THREE MILE ISLAND, UNIT 1 (TMI UNIT 1)
OPERATING LICENSE NO. DPR-50
NRC DOCKET NO. 50-289

SUBJECT: Response to NRC Staff Follow-Up Questions 1 through 4 from
November 9, 2001 Meeting Regarding a TMI Unit 1 Steam Generator
Severed Tube

**Response to NRC Follow-Up Questions from November 9, 2001 Meeting
Regarding the TMI Unit 1 Steam Generator Severed Tube**

Figure 1. SEM mosaic of fracture face of TMI-1 tube no. B66-130

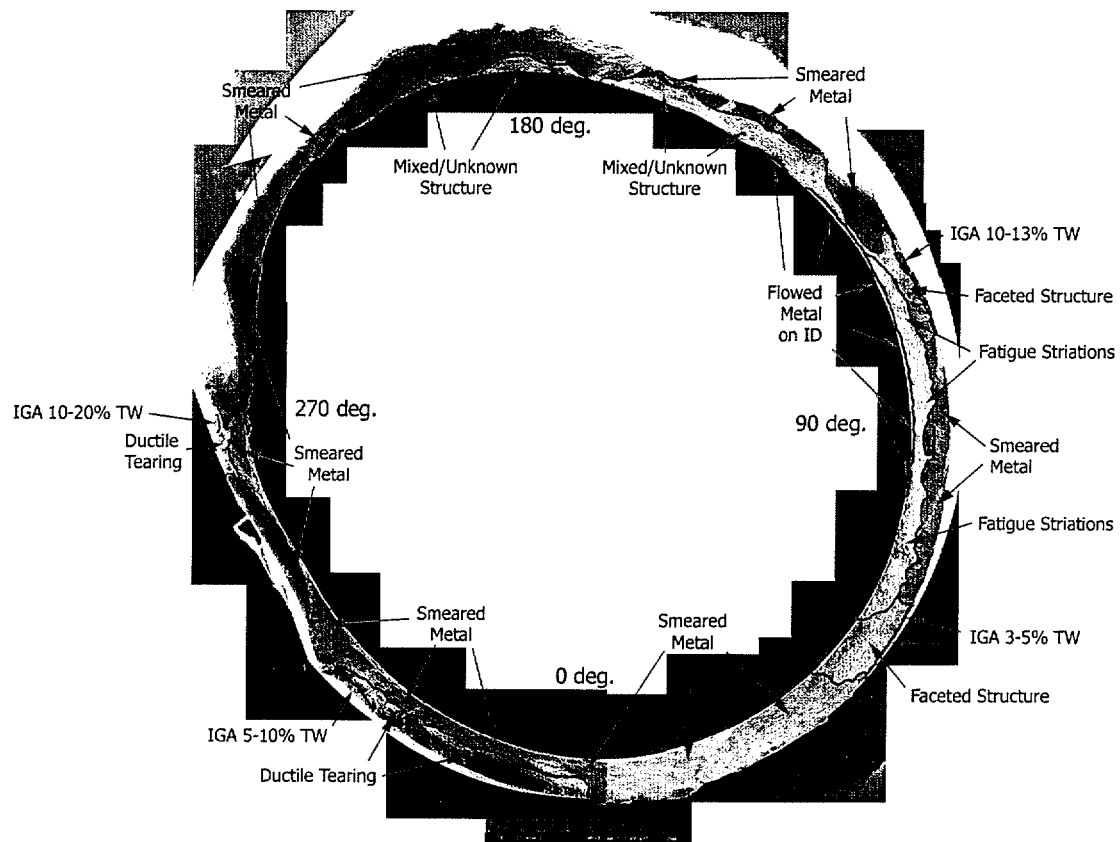
1. Please provide a montage of high magnification fractographs to augment the fracture surface map provided to the NRC staff on November 15, 2001 (which is attached as an addendum to the meeting handout in Enclosure 2). The fractographs should be annotated, including magnification and orientation, and should describe the significant features of the fracture surface. The fractographs should demonstrate examples of the features identified on the fracture surface map (e.g., IGA, fatigue striations, pueblo structure, flowed metal, ductile tearing and smeared metal). Provide a discussion of the fracture surface features as they relate to the postulated failure sequence of events, i.e., outer diameter (OD) IGA as points of origin for fatigue propagated by flow induced vibration, followed by ductile tearing.

A low-magnification Scanning Electron Microscopy (SEM) mosaic of the entire fracture surface is shown in Figure 1. As can be seen in Figure 1, much of the fracture surface was smeared, or burnished, by the rubbing of the fracture surfaces against each other during the failure process. After the tube separated, additional fracture surface was lost by abrasion when the tube rubbed against the adjacent tubes. Nevertheless, it was possible to identify several regions of OD intergranular attack (ODIGA), fatigue damage, and ductile tearing. These regions of interest are identified in Figure 1. In the discussion that follows, reference is made to several SEM fractographs to illustrate the regions of specific damage. In all of the fractographs presented, the vertical orientation of the images is preserved with respect to Figure 1; i.e., the 0° reference is toward the bottom of the figure, and the 180° reference is toward the top of the figure. Rotational orientation is counterclockwise from the 0° reference.

Figure 1. Etched cross-section of expanded section of tube no. 65-130 showing the presence of ODIGA (500X)

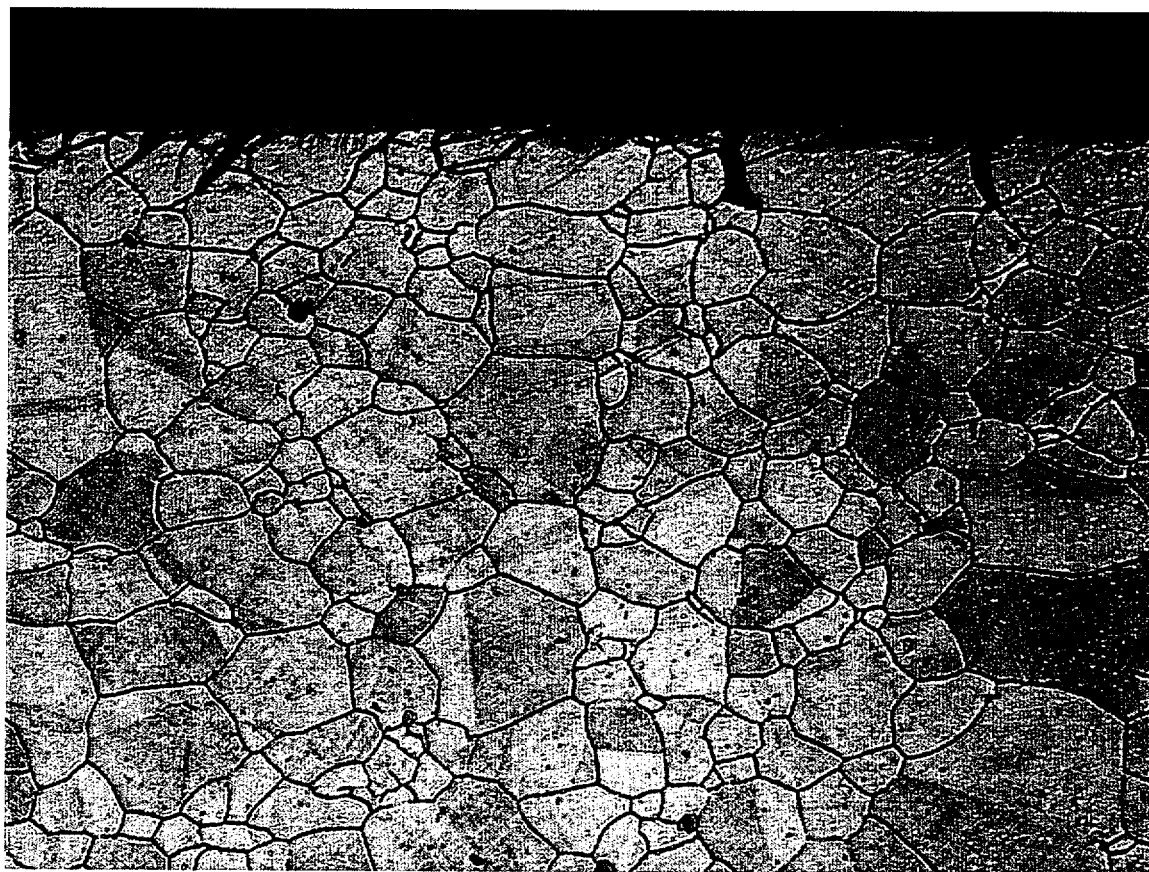
2. Summarize the results of the metallography, hardness measurements, and mechanical testing that have been completed on the severed tube and other harvested tubes. Describe the locations of the test specimens (or hardness tests) relative to the fracture surface location. Relate these results to the postulated failure mechanism.

A sample of tubing removed from approximately 13 – 27 inches below the upper tube sheet face, tube 65-130, was hydraulically swelled approximately 8.6% from 0.626 to 0.680 inches OD at a pressure of 9,784 psi. A photomicrograph of the expanded portion of the tube shows shallow ODIGA 1-2 grains deep (Figure 1). This is typical for tubing in the steam space of B&W OTSGs. No other microstructural anomalies were observed and the microstructure is typical of sensitized Alloy 600 tubing, with carbide decoration of the grain boundaries.
